# **Flawed Reactor Pressure Vessels in Belgian Nuclear Plants Doel-3 and Tihange-2**

## ***Some Comments***

Ilse Tweer

January 2013

Figure 1: Reactor Pressure Vessel Doel 3

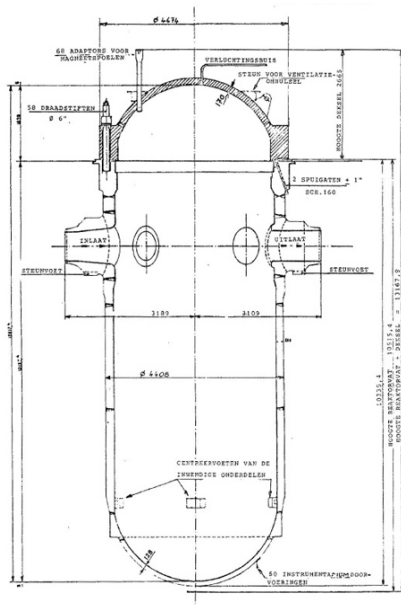
- A significant disparity in the flaw densities between the upper and the lower shell rings is obvious.

Figures 2a and 2b: Underclad cracks (a) and hydrogen-induced flaws (b)

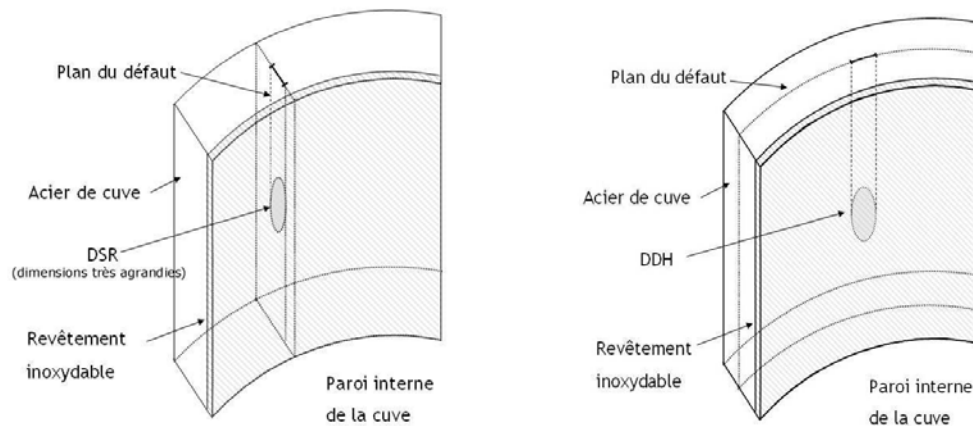
- The existence of underclad flaws is expected by the Standards, but the type of flaws observed is not described. Therefore no appropriate UT<sup>8</sup> techniques have been developed, and regular testing of the base metal in the cylindrical RPV part is not foreseen.

While underclad cracks are directly under the stainless steel cladding oriented normal to the inside surface of the RPV wall, the observed flaws are parallel to the wall surface (see the following figures<sup>9</sup>; DSR<sup>10</sup> are underclad cracks, DDH<sup>11</sup> the hydrogen-induced flaws).
